Determination 2013/046

The code-compliance of top vented cavities proposed for the wall cavities to two Gisborne school buildings

- 2.3.1 The indicative sketch in Figure 1 shows the general concept required by MOE and proposed for the top of wall cavities:

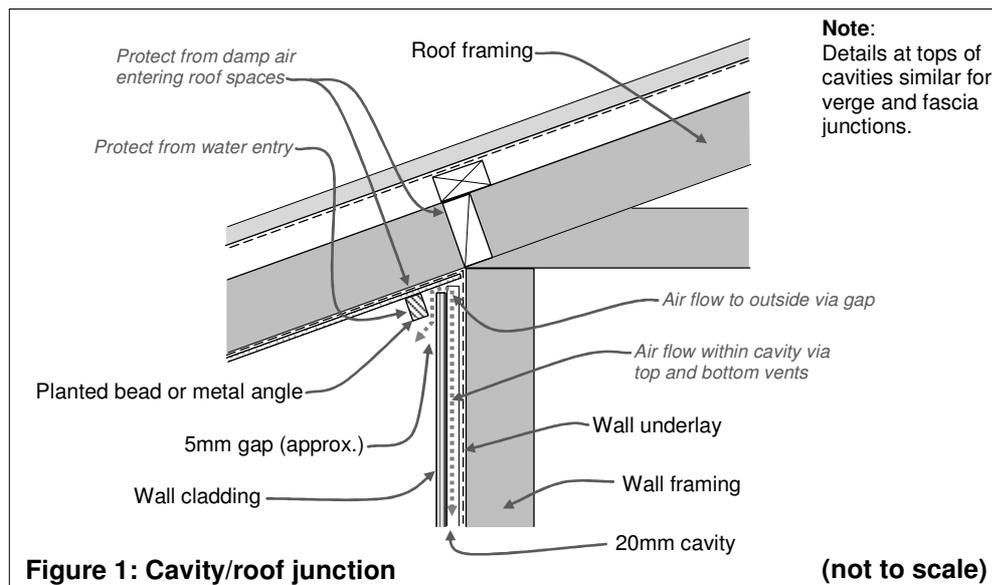
- 2.3.2 The junction provides ventilation within the cavity by way of a gap of about 5mm at the top to allow air flow to the outside, while protecting the junction from water penetration with the use of planted beads or metal angles. The roof and eave framing is intended to be sealed from damp air with blocking and wall underlay.

4.2.1 In response to queries, the authority wrote an email to the Ministry dated 20 May 2013 outlining reasons for refusing to accept the proposed top venting to wall cavities (in summary):

- the BRANZ report is ambivalent on the efficacy of adding ventilation via top venting as, although there may be some advantage, there is the added caveat of vermin and weatherproofing

- the BRANZ report also states that bottom only vents are working better than expected due to additional and unforeseen air infiltration paths
- experience shows that many schools have contracted and programmed painting/washing cycles, involving routine washing that is likely to be done by the quickest and easiest method

- routine washing will generally use high pressure water blasting, which will inevitably lead to water ingress at the soffit to wall junction
- given the admission that the bottom vents could get blocked, water penetration through top vents is likely to turn the cavity into a 'tank'

- as there is no problem with E2/AS1 cavity design, the addition of top vents is 'a problematic alternative solution that will provide no added advantages, and may actually detract from the building weathertightness'.

The Compliance Documents	The proposed top venting <i>(In principle - refer Figure 1)</i>
<p>Clause E2</p> <p>E2.3.2 The proposed junction must prevent the penetration of water.</p> <p>E2.3.5 The proposed junction must prevent the transfer of moisture into concealed spaces such as the roof framing.</p> <p>E2.3.7(a) The proposed junction must make allowance for the consequences of failure.</p> <p>E2.3.7(c) The proposed junction must make allowance for variation in the properties of materials</p>	<p>The junction incorporates screening in the form of planted beads, metal angles or similar to prevent rain entering the cavity.</p> <p>Wall underlay seals off eaves framing, with blocking/purlins sealing off roof framing.</p> <p>Should moisture penetrate into the wall cavity, the additional top vents will provide higher ventilation rates and drying potential than bottom-only vents.</p> <p>Specific top vents provide engineered air flow that does not depend on construction quality, finish and cladding type.</p> <p>The proposed system is adaptable to common types of junctions and wall claddings.</p>

<p>E2/AS1 The drained cavity is not vented at the top.</p> <p>The drained cavity shall use vermin-proofing.</p>	<p>The junction incorporates a gap of about 5mm to allow air flow at the top of the cavity</p> <p>The cavity base closer has holes or slots between 3mm and 5mm to provide vermin proofing.</p>

- 6.3.3 Taking the above into account, I consider it likely that the addition of carefully detailed top vents is likely to improve air flow within wall cavities without any apparent disadvantages. Notwithstanding the adequacy of wall cavities with vents only at the bottom, the proposed top venting of wall cavities will therefore in principle provide weathertightness beyond the minimum required.

- 6.4.1 In the case of wall cavity to roof junctions proposed for school buildings, the BRANZ report and the other evidence have provided grounds for me to be satisfied that the proposed top vents to wall cavities, appropriately detailed to provide protection against moisture penetration and transfer, will comply with Clauses E2 and B2 of the Building Code.

- 7.1 I suggest the architect now modify the applications, taking into account the findings of this determination and clearly detailing the protective measures indicated in Figure 1 adapted to suit the specific circumstances of each project.
- 7.2 I note that the detailed examination of construction details for weathertightness remains the responsibility of the authority and not the Ministry. If remaining details cannot be agreed with the authority, any items of disagreement can then be referred to the Chief Executive for a further binding determination.
